MEMORANDUM CRA

RE: Zoning in Progress ordinance - western theme district

AN ORDINANCE OF THE TOWN OF DAVIE, FLORIDA, AMENDING SECTION 12-388 OF THE TOWN CODE BY AMENDING SUBSECTION (A)(1) CONCERNING FRONT SETBACKS, SUBSECTION (C) CONCERNING COVERED BOARDWALKS, AND ADDING A NEW SUBSECTION (J) CONCERNING MINIMUM FRONT WALL HEIGHT IN THE WESTERN THEME DISTRICT; PROVIDING FOR SEVERABILITY; AND PROVIDING AN EFFECTIVE DATE.

ILLUSTRATION
MEAN HEIGHT CALCULATION FOR FRONT WALL

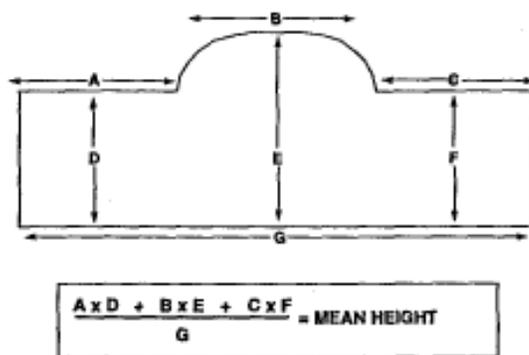
(J) Minimum front wall height: Eighteen (18) feet. The mean height of the front walls of

buildings shall be at least twenty one (21) feet. Such front wall height shall be measured from the finished floor elevation to the top of the front wall. Rounded and angled parapet features shall be calculated as squared and rectangular shapes. The height of a shed or gabled roofed building which does not have a front parapet shall be measured from the finished floor elevation to the midpoint of the roof line which midpoint shall have a minimum height of eighteen (18) feet. Building alterations which do not alter the existing front wall structure are exempt from this subsection (j). The following is an example of mean height calculated for front walls.

TYPICAL BUILDING PLACEMENT UNDER PROPOSED BUILD TO LINE

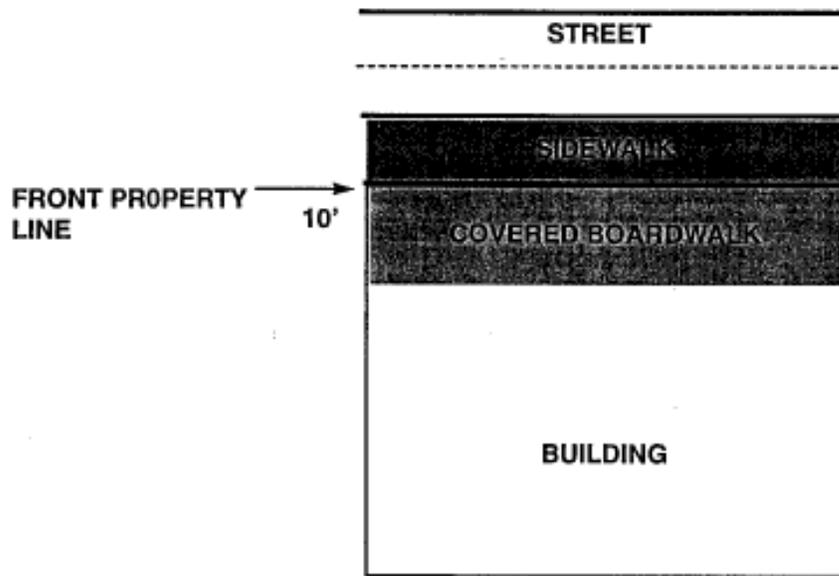
of Davie Road, the properties can: 1) follow the recommended 10 foot built to line standard (see Exhibit B which is the typical building placement recommended for entire district), 2) provide a front bufferyard up to the front boardwalk area (with no front vehicular use areas), or 3) if the owner wants front parking, then he must provide a minimum bufferyard area. West of Davie Road there were two options recommended: 1) follow the recommended 10 foot built to line standard, and 2) provide a front bufferyard up to the front boardwalk area (with no front vehicular use areas)(see Exhibit C). The CRA believes that the removal of the school board properties in front of the existing Old Davie School could generate additional pedestrian activities on the south side of the C-11 canal. This activity could promote new businesses nearby to take advantage of this attractive setting. In addition, the CRA provided initial support for the proposed neighborhood center plan that was recommended by Planning & Zoning staff for the southwest neighborhood at Griffin and Davie Road. These two important items are the reasons why this area of the Western Theme District should be treated unique for Griffin Road, and even different from the east side of Davie Road. However, the CRA believes that if a property owner wishes to develop his property closer to the street, it will better define the area as an entranceway into the Davie Road corridor.

(1) Front Setback: Ten (10) feet. In order to provide a linear uniformity of buildings in this district, the ~~recommended~~ required building walls for the ground floor of buildings ~~should~~ shall be ~~exactly built to~~ ten (10) feet from the front property line, and fifteen (15) feet for buildings with first floor outdoor seating areas. The recommended front setback for upper floors is exactly ten (10) feet. Upon an intersection with two or more streets, the front shall be determined by the side of the building facing the street with the higher number of lanes of traffic. Upper floors may be built with a front setback standard of zero (0) feet, however, upper floors may not extend beyond a maximum distance of ten (10) feet from the ground floor building wall. Properties abutting the southern right of way line of Griffin Road may alternatively provide for one of the following:

GRIFFIN ROAD OPTIONS

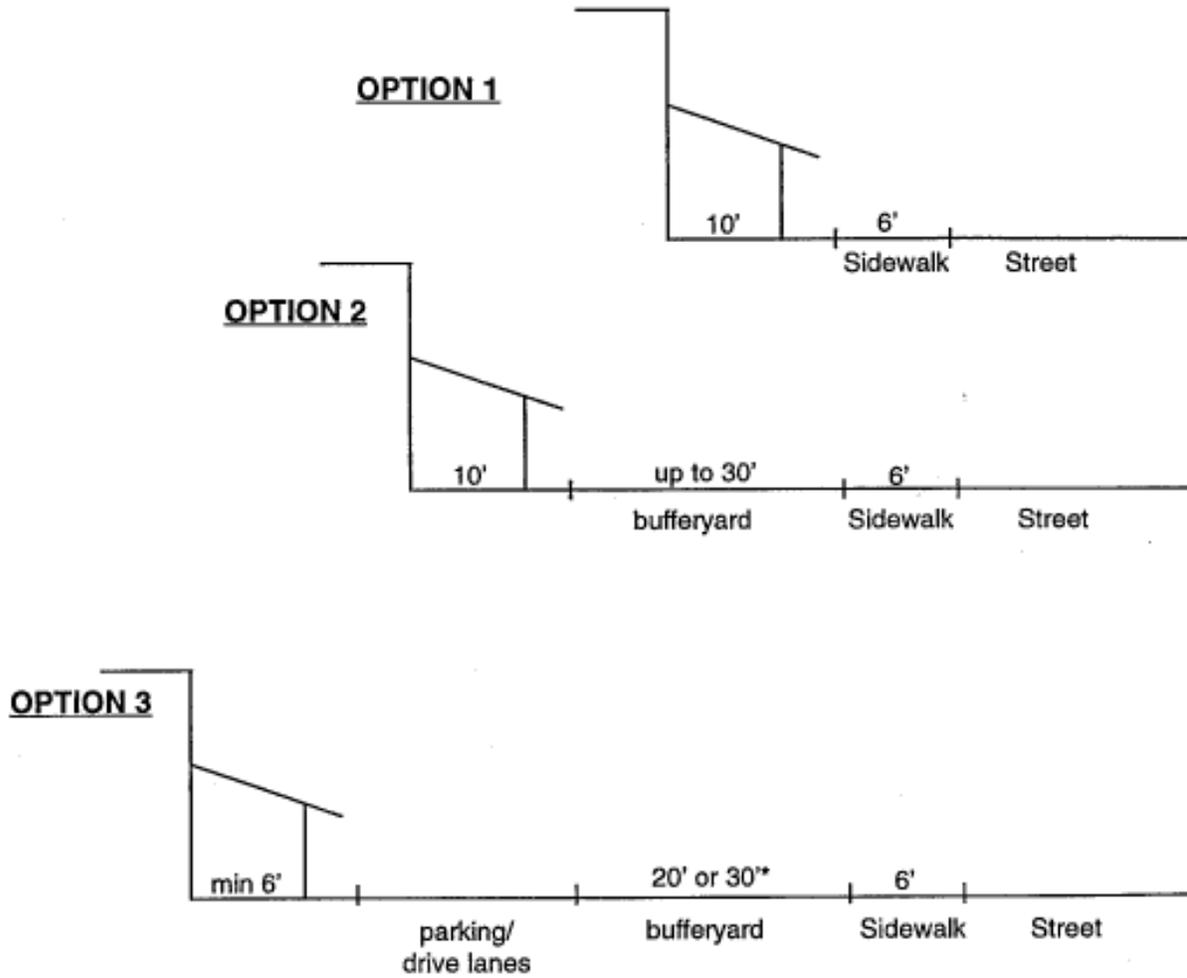
Options 1, 2, and 3 are available east of Griffin Road

Options 1, and 2 are available west of Griffin Road

*20' if elevation difference is less than or equal to 2'

30' if elevation difference is greater than 2'

Properties east of Davie Road shall be as follows:

(a) a building wall to be built ten (10) feet from the front property line with a covered boardwalk as required under subsection (C) below, or

(b) a landscaped bufferyard of up to a maximum of thirty (30) feet on the Griffin Road frontage with a front covered boardwalk of a minimum width of ten (10) feet. The covered

boardwalk shall abut the bufferyard, or

(c) Parking and drive lanes placed in the front of the building, in accordance with the following conditions:

(1) If the Griffin Road edge of right-of-way elevation as determined by the Florida Department of Transportation exceeds two (2) feet from the property elevation at the Griffin Road property line, a thirty (30) foot bufferyard shall be placed adjacent to the Griffin Road right-of-way.

(2) If the Griffin Road edge of right-of-way elevation as determined by the Florida Department of Transportation is equal or less than two (2) feet from the property elevation at the Griffin Road property line, a twenty (20) foot bufferyard shall be placed adjacent to the Griffin Road right-of-way.

(3) There shall be no maximum building setback requirement.

(4) A covered boardwalk as required by subsection (C) below.

Properties west of Davie Road shall be as follows:

(a) a building wall to be built ten (10) feet from the front property line with a covered boardwalk as required under subsection (C) below, or

(b) a landscaped bufferyard of up to a maximum of 30 feet on the Griffin Road frontage with a front covered boardwalk with a minimum width of ten (10) feet. The covered boardwalk shall abut the bufferyard.
